Office Action Summary	Application No. 10/813,589	Applicant(s) PAUL ET AL.	
	Examiner Michael B. Shingleton	Art Unit 2815

DETAILED ACTION***Claim Rejections - 35 USC § 103***

Claims 47-62 are rejected under 35 U.S.C. 103(a) as being unpatentable over Koinuma US4,451,802 (Koinuma) in view of King US 6,300,827 (King), Engbretson US5,311,150 (Engbretson), Dudley et al. US5,144,133 (Dudley) and Lu et al. US 6,009,023 (Lu).

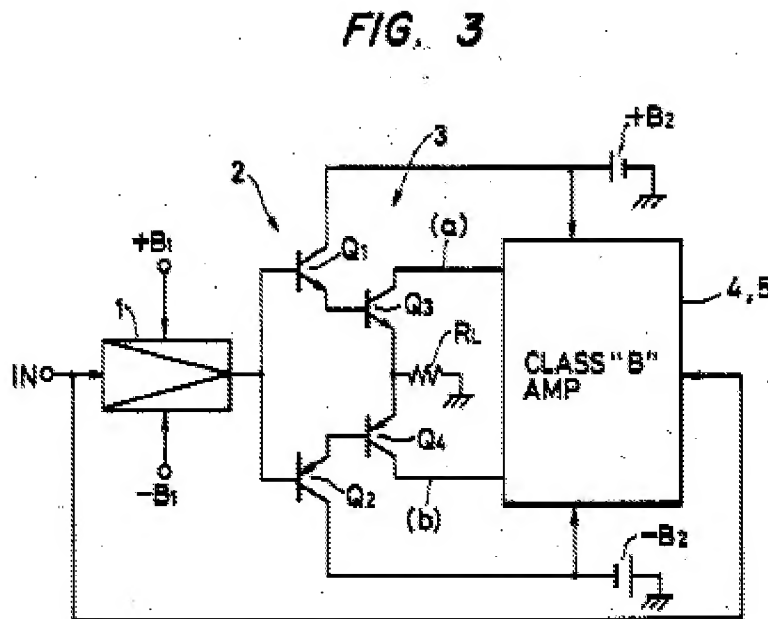
Figure 3 and the relevant text of Koinuma disclose a power amplifier arrangement and method of providing an amplifier with a preamplifier 1 (input stage) and an output stage (2 and 3) that is supplied with two different power sources (B_1 and B_2). The voltage B_2 is of a greater magnitude than that of B_1 . (See column 3, around line 36)

Figures 2 and 3 of Dudley.

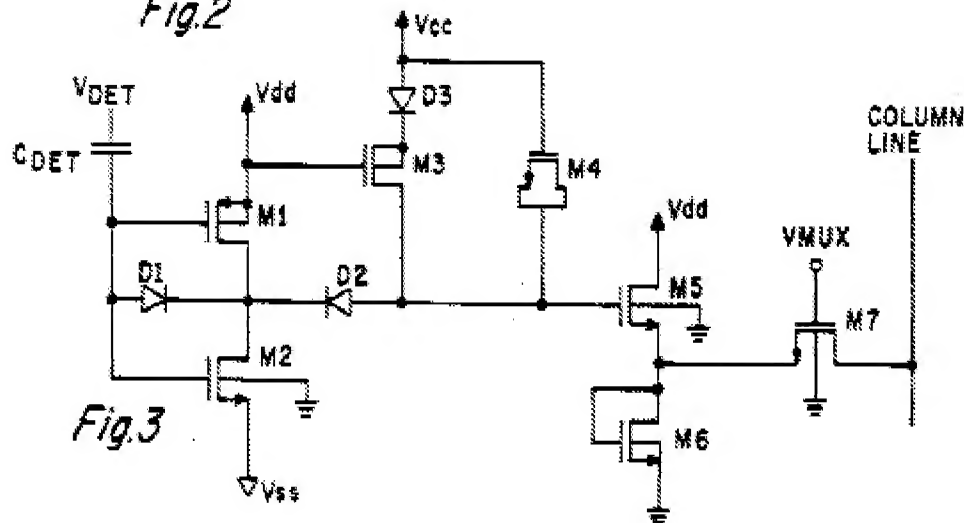
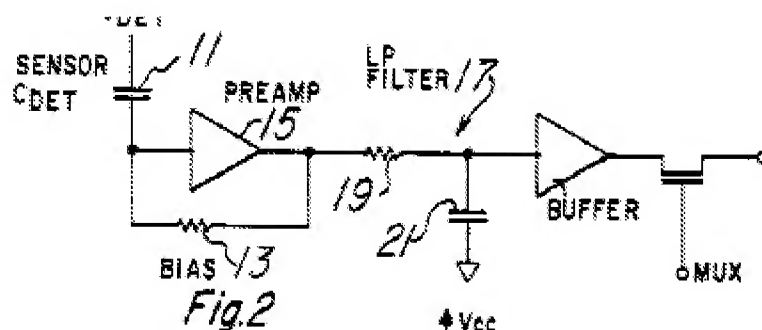
As to the CMOS input stage, Koinuma is silent on the exact construction of this stage. This is evidence that a conventional amplifier stage could be used. A specific structure that would be required other than the conventional is not recited and all Patents are presumed valid. 35 USC 282. Dudley in Figures 2 and 3 specifically recites that one conventional preamplifier stage is one that uses CMOS technology and thus that would inherently include FET structure.

Accordingly, it would have been obvious to one of ordinary skill in the art at the time the invention was made to replace the generic amplifier of Koinuma with a CMOS based unit because as the Koinuma reference is silent on the exact structure of the preamplifier stage one of ordinary skill in the art would have been motivated to use any art-recognized equivalent preamplifier structure such as the CMOS based structure of Dudley.
